**Notice of Meeting for the
Historic and Architectural Review Commission
of the City of Georgetown
September 9, 2021 at 6:00 PM
at 510 W. 9th Street Georgetown, Texas 78626 Council and Courts Building**

2021-34-COA– 404 E. 4th Street Infill

2021-41-COA – Martin Fence

Proposed Site Plan

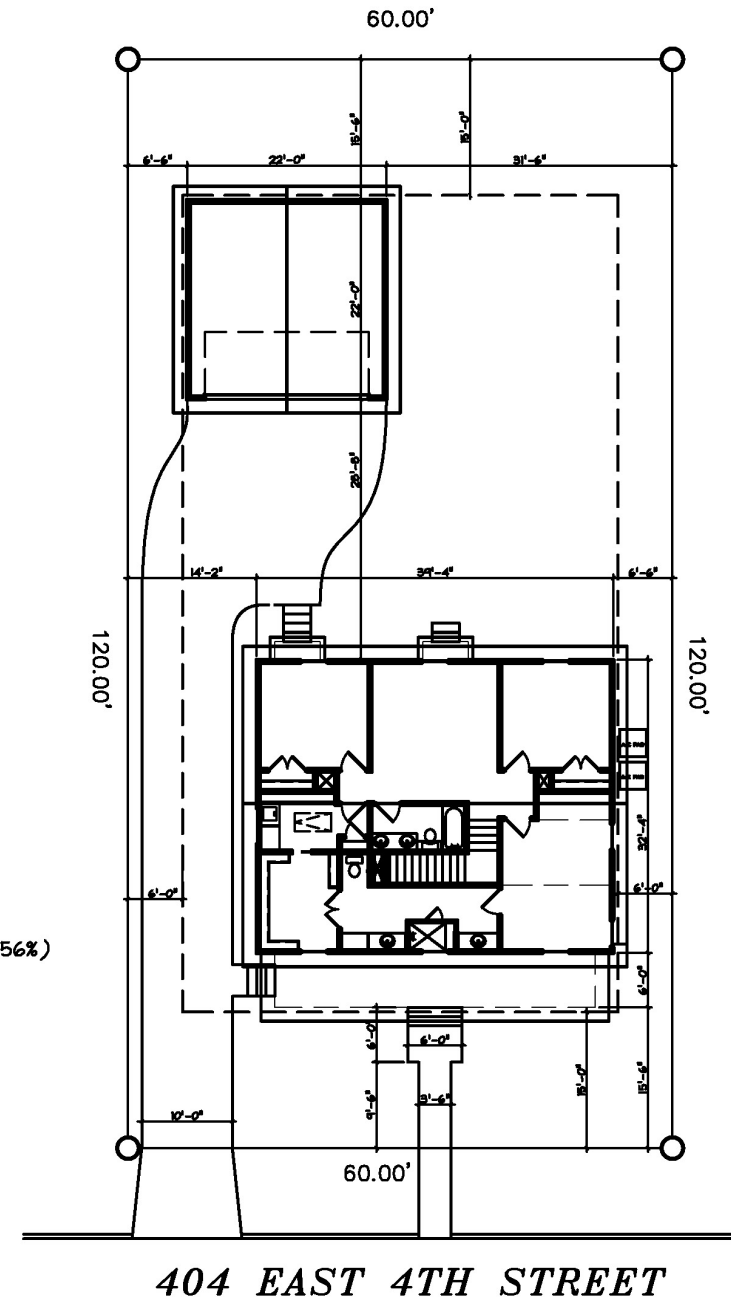
Utility Easement (PUE) exists at the rear of the property and the new structures cannot be constructed to the rear 10' setback as structures cannot be located within a PUE. The applicant is therefore requesting a 5' front setback modification, which would shift the structures 5' closer to the front property line to account for the PUE, and which would also align the front façade with structures on adjoining properties and along the block.

Staff recommends ***approval*** of the request for infill construction with a setback modification.

Proposed Elevations

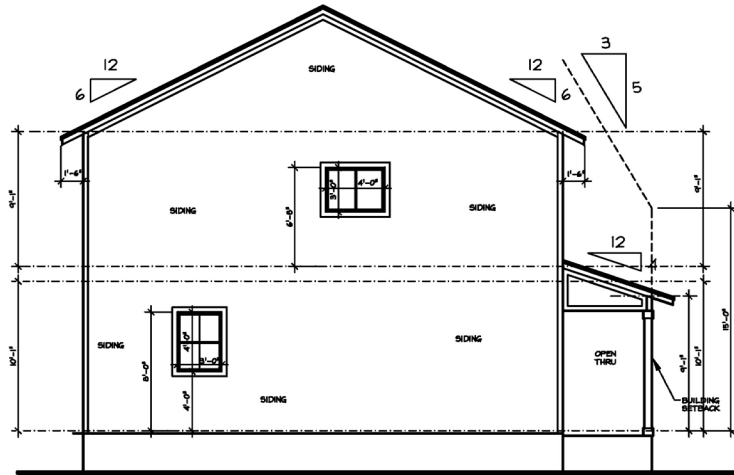
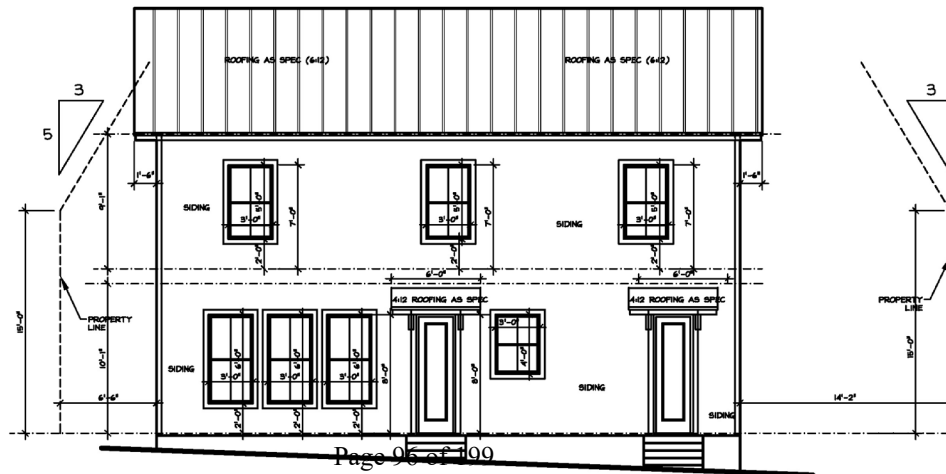
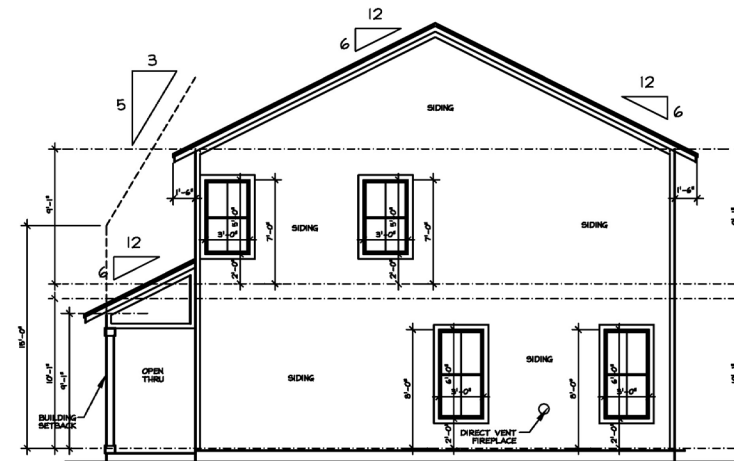
<p>14.6 Where a large building is needed, divide the building into modules that reflect the traditional size of residential buildings</p> <ul style="list-style-type: none">✓ A typical building module should not exceed 20 feet in width. The building module should be expressed with at least one of the following:<ul style="list-style-type: none">– A setback in wall planes of a minimum of 3 feet– A change in primary façade material for the extent of the building module– A vertical architectural element or trim piece.✓ Variations in façade treatments should be continued through the structure, including its roofline and front and rear façades.	<p style="text-align: center;">Complies</p> <p>The proposed structure is approximately 40' wide and not large enough to divide into modules, but the primary façade is enhanced by a full-width porch.</p>
<p>14.10 - Non-traditional siding materials are discouraged.</p> <ul style="list-style-type: none">✓ Typically, artificial stone and brick veneer are not appropriate.✓ Asphalt shingles are not appropriate.✓ Aluminum and vinyl are not appropriate.	<p style="text-align: center;">Complies</p> <p>The siding is fiber composite lapped siding with fiber composite trim, which has an appearance similar to wood siding when painted.</p>

New Porch Photos

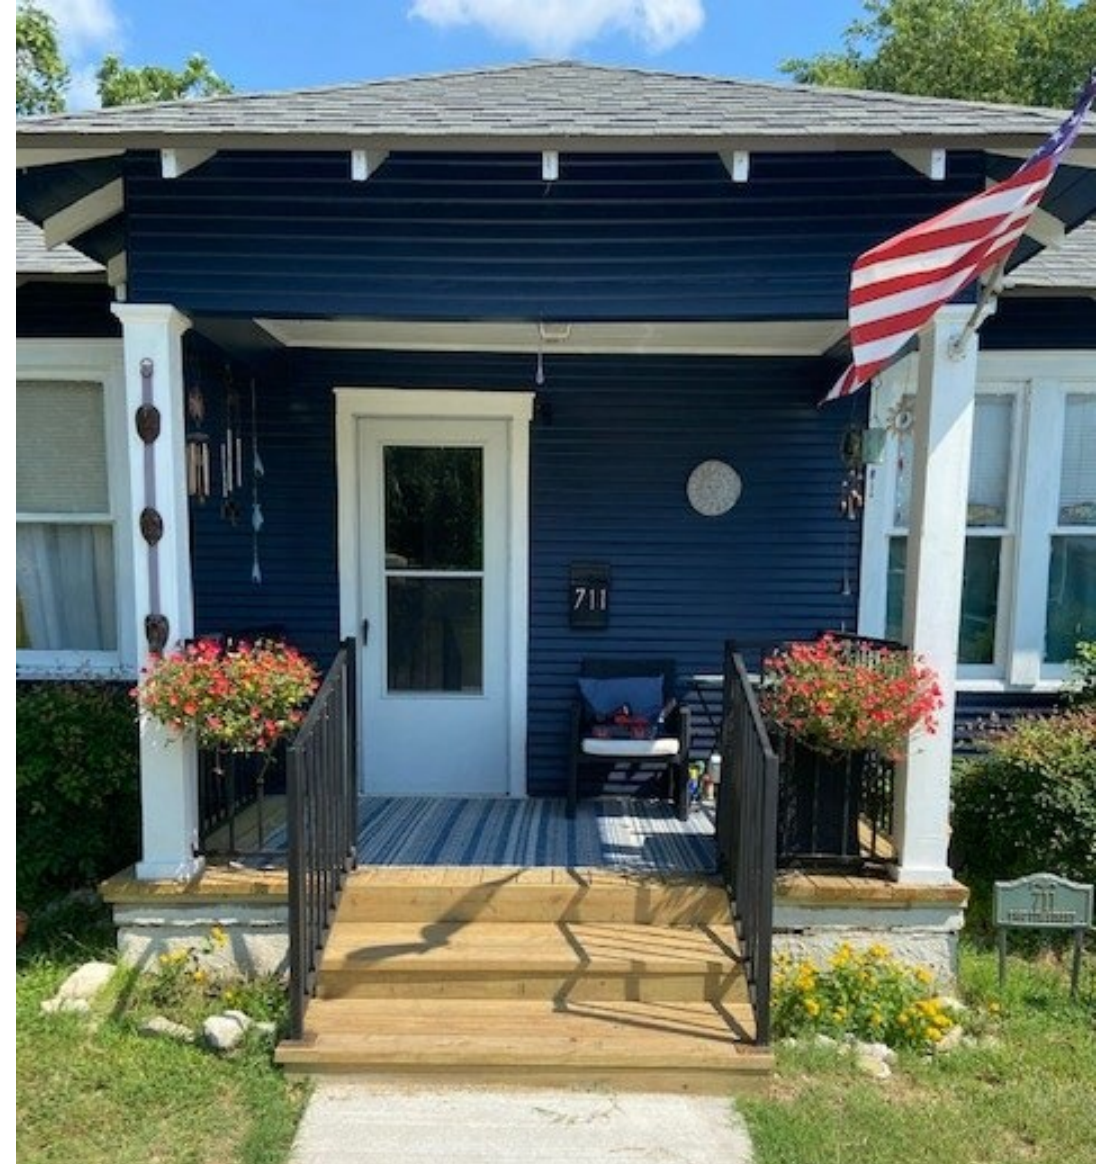
The applicant is requesting HARC approval of changes to the front porch of a medium priority structure in the Old Town Overlay District. Although the 1984 and 2016 Historic Resources list construction dates of 1920 and 1930, respectively, photos and Sanborn maps show the house and garage to have been constructed between 1934 and 1940. The 1984 Historic Resource Survey photo does not show porch railings, and the porch may have originally been wood, although it is currently concrete.

Due to ongoing issues with water drainage back toward the foundation of the house and a need for more secure and safe stair railings, the property owner found it necessary to replace the prior wood railings with metal railings, add railings for the stairs, and to add wood flooring to the porch to correct a slope issue and provide a safer walking surface. The owner is also proposing to install painted fiber cement

GUIDELINES	FINDINGS
CHAPTER 6 – DESIGN GUIDELINES FOR INDIVIDUAL BUILDING ELEMENTS	
<ul style="list-style-type: none">✓ Unless used historically, wrought iron porch posts and columns are inappropriate.✓ Where an historic porch does not meet current code requirements and alterations are needed or required, then retrofit it to meet the code, while also preserving original features. Do not replace a porch that can otherwise be modified to meet code requirements.✓ A missing porch and its steps should be reconstructed, using photographic documentation and historical research, to be compatible in design and detail with the period and style of the building.✓ Most precast concrete steps are not acceptable alternatives for primary façade porches.✓ Construction of a new non-original porch is usually inappropriate.✓ The construction of a non-original second or third level porch, balcony, deck, or sun porch on the roof of an existing front porch is inappropriate.	surface and iron railings and handrails for safe use of the stairs and porch, which have a railing diameter that is easier for the owner to hold onto when using the stairs. Although the new railings and handrails are a change from the previous materials and design, the 1984 photo of the property does not show that the porch had railings at the time, and the previous wood railing is not assumed to be historic.

5. The general historic, cultural, and architectural integrity of the building, structure or site is preserved;	Complies The 1984 HRS photos show that the wood railings were not original to the porch, and the installed railings and porch boards and steps do not diminish the character of the structure.

Proposed Fence

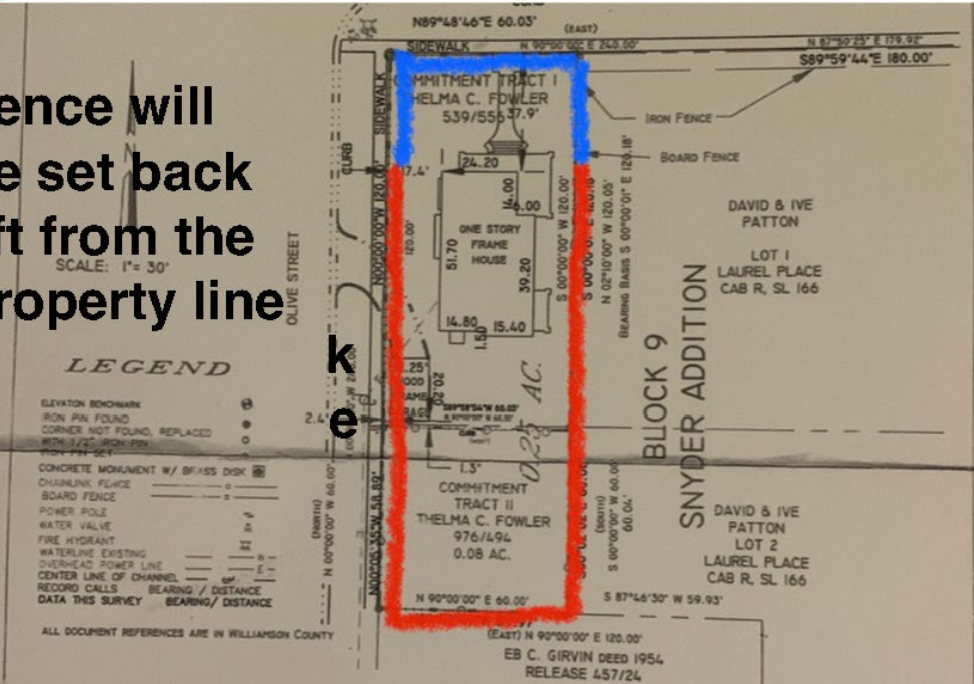
The applicant is requesting HARC approval of a new 5' tall iron fence along the side street property line to enclose the rear yard with a taller fence than the 3' tall fence planned for the front yard. In the Old Town Overlay District, fence height along front and side street property lines is limited to 3' in height and 50% transparency unless an alternate fence is approved by HARC. The proposed iron fence has more than 50% transparency and includes decorative details similar to the existing fence on the abutting property to the east of the subject property. 6' tall privacy fences are permitted if they are set back a minimum of 15' from the side street property line, and the applicant would be able to construct the requested fence behind that 15' setback; however, they are requesting the 5' fence along the side street property line to be able to enclose a larger portion of the rear and side yard for pets.

**Fence will
be set back
3ft from the
property line**

Red highlight/outline
represents the proposed
5ft high fence
placement
